PETITION FOR CHANGE OF THE PROJECT DESCRIPTION IN THE FINAL DECISION TO EXPAND THE ADMINISTRATIVE BUILDING PALOMAR ENERGY CENTER

(**O1-AFC-24C**)

SAN DIEGO GAS & ELECTRIC COMPANY SAN DIEGO, CALIFORNIA

CALIFORNIA ENERGY COMMISSION

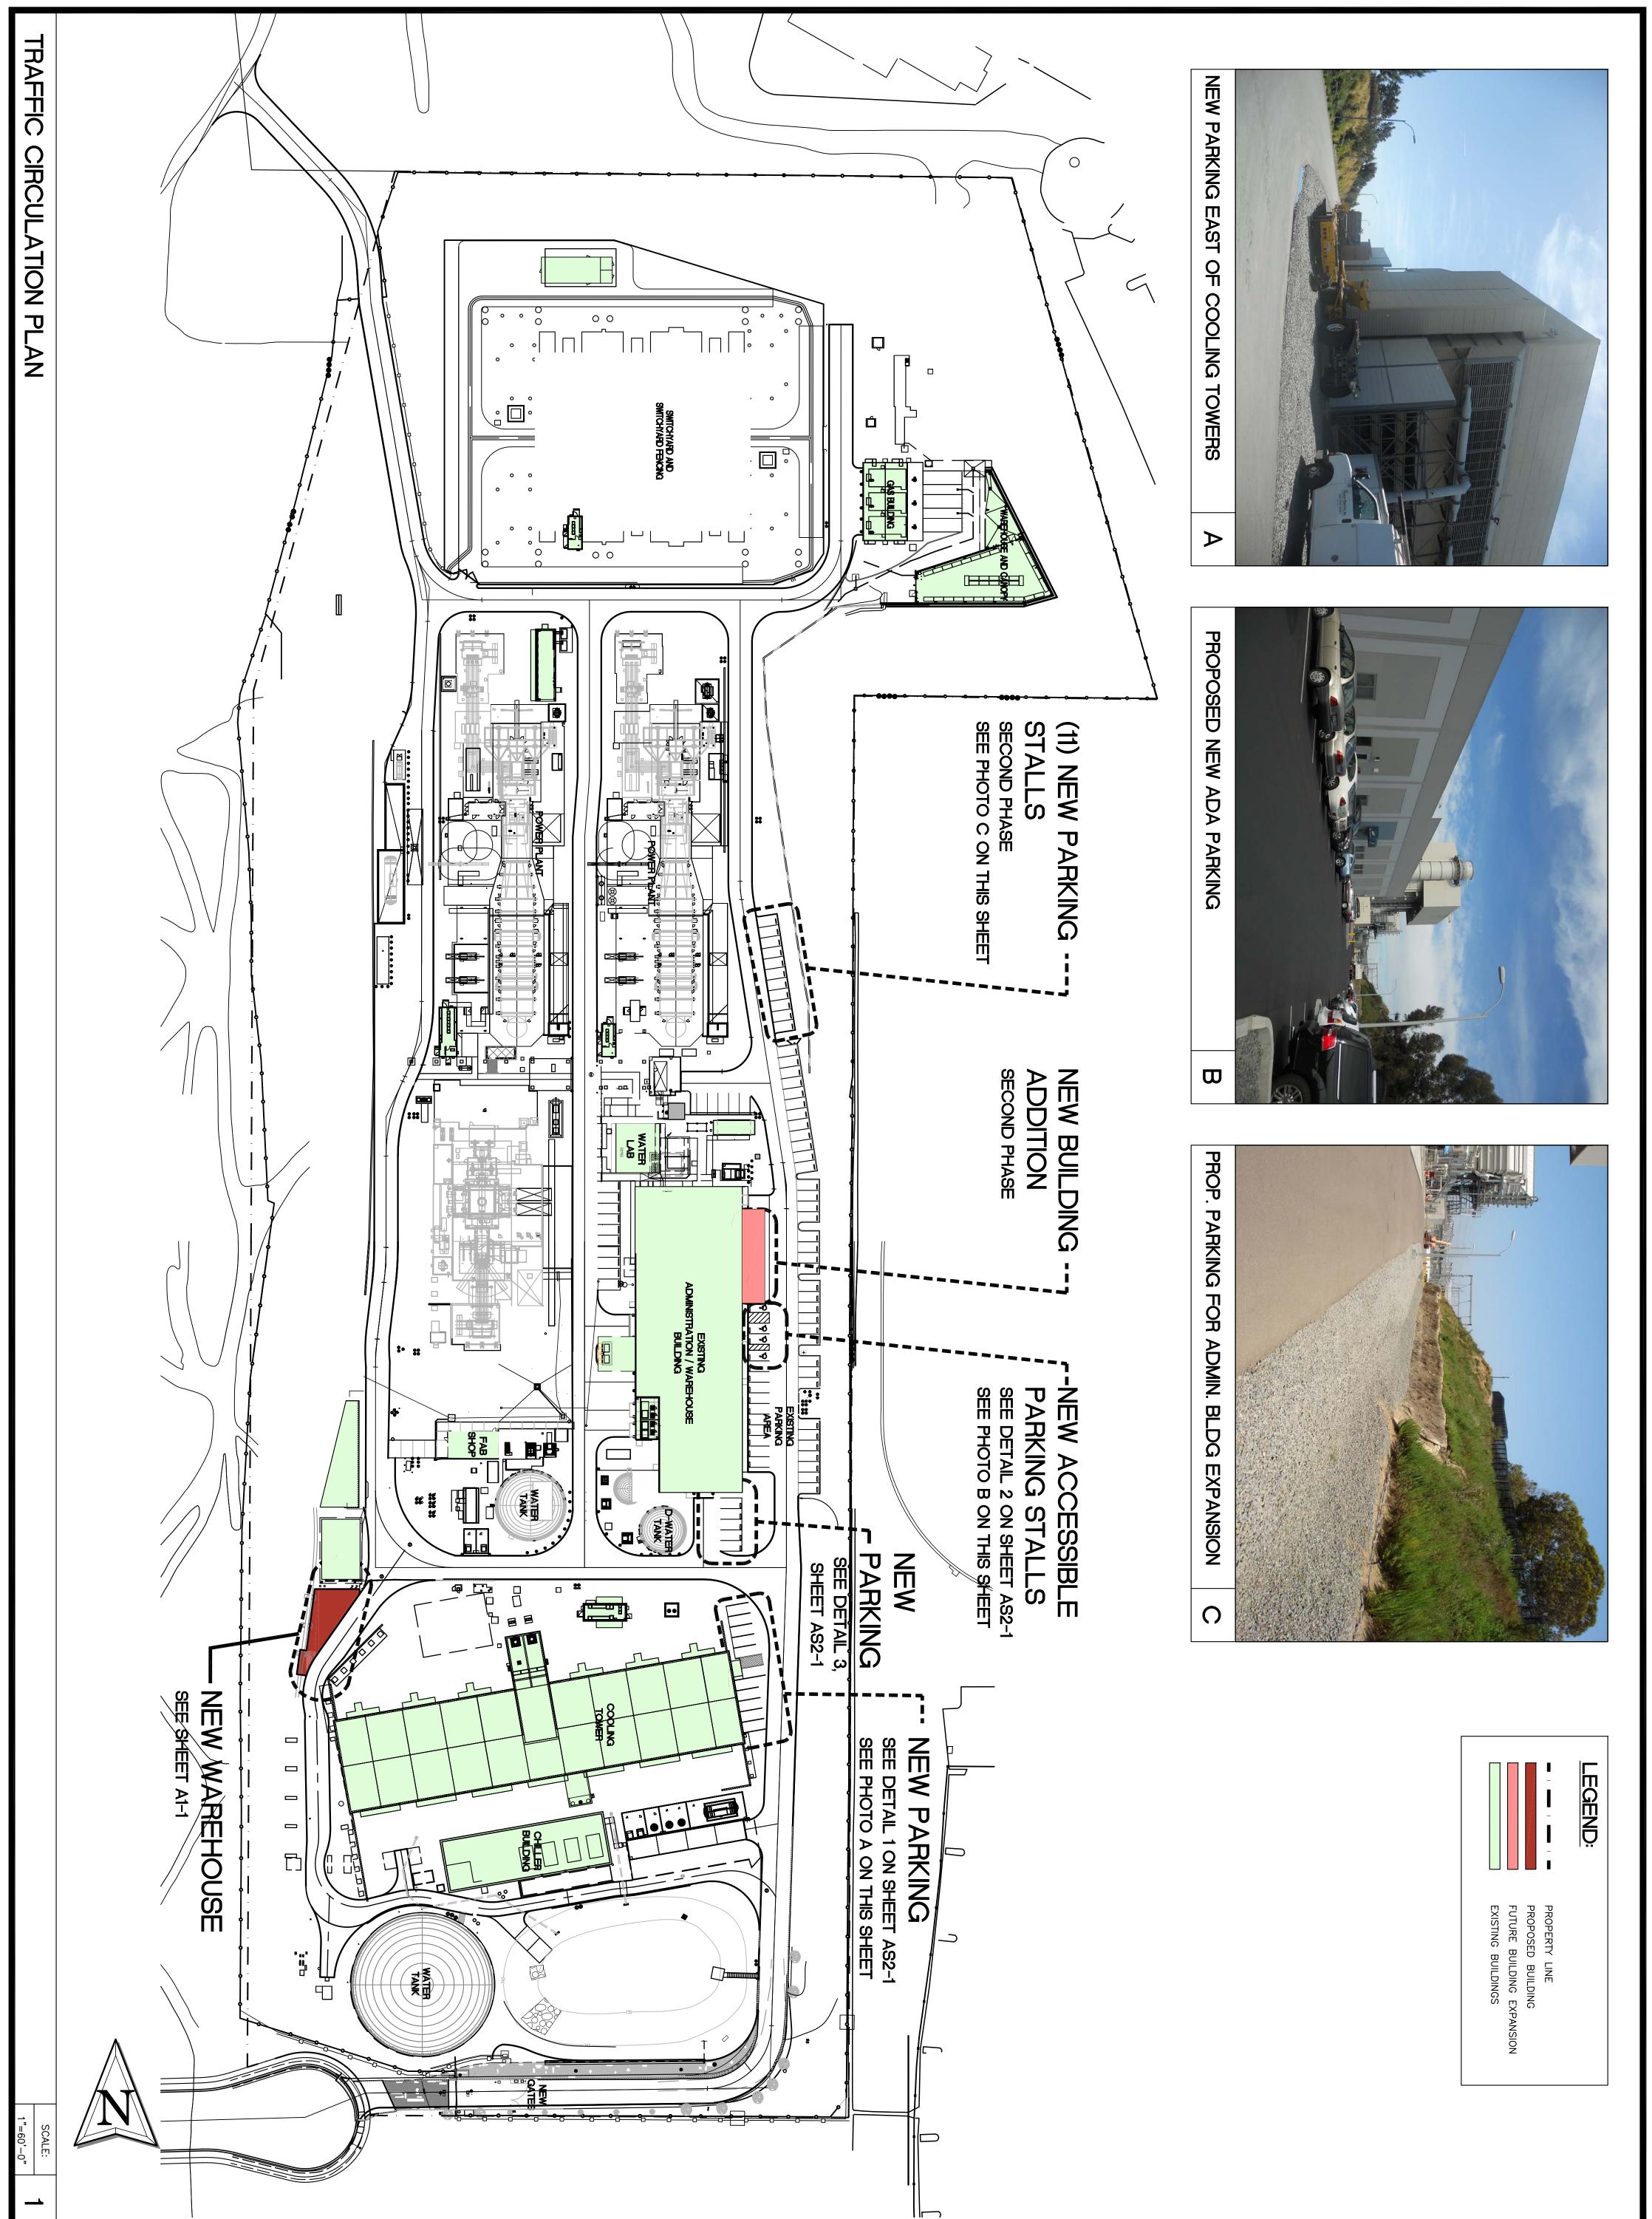
Administrative Building Expansion. SDG&E is proposing to build a two-story addition on the east side of the existing administrative building. This addition will add approximately 1500 square feet of available administrative office space. A new building entrance would be located on the south side of the addition. The expansion would also include a new 4-foot sidewalk extension along the new east and north walls and a canopy over the new building entrance. The administrative building expansion would extend into

the existing parking area along the east wall of the building; therefore; eight existing parking spaces would be eliminated. To replace the lost parking, this project will add two parking places north of the addition and six other spaces would be developed within the facility boundaries. The project will include re-striping the existing ADA parking within the area. Also, the project proposes adding 5 new parking spaces, as a result of added square footage of new office space. The site plan drawing and building expansion simulation shows the overall details of the project and gives a visual simulation of the structure once completed. (Appendix 1)
